SI B11 14 15  
Engine

This Service Information bulletin supersedes SI B11 14 15 **dated October 2015**.

**Service Action: N55 Engine - Inspect and Replace Engine Oil Filter Housing**

F30 (3 Series Sedan)

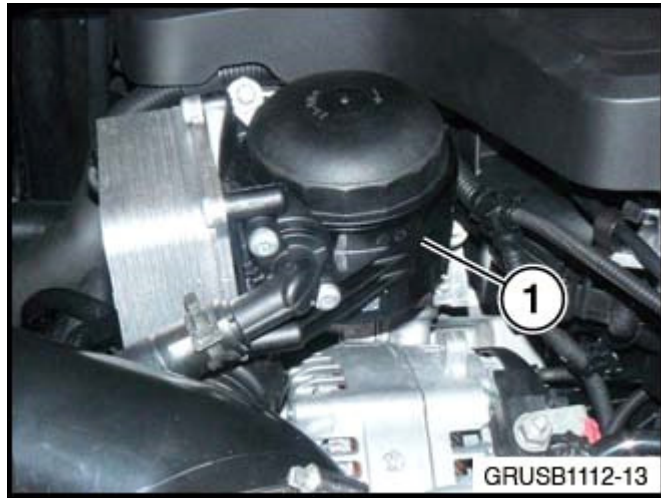
1. Inspect and replace the engine oil filter housing as per the repair instructions.

2. If the vehicle is fitted with the aluminum oil filter housing (silver color) then take no further action. Do not replace any parts.

3. If the vehicle is fitted with the plastic engine oil filter housing (black color) then replace the engine oil filter housing as per the attached instructions.
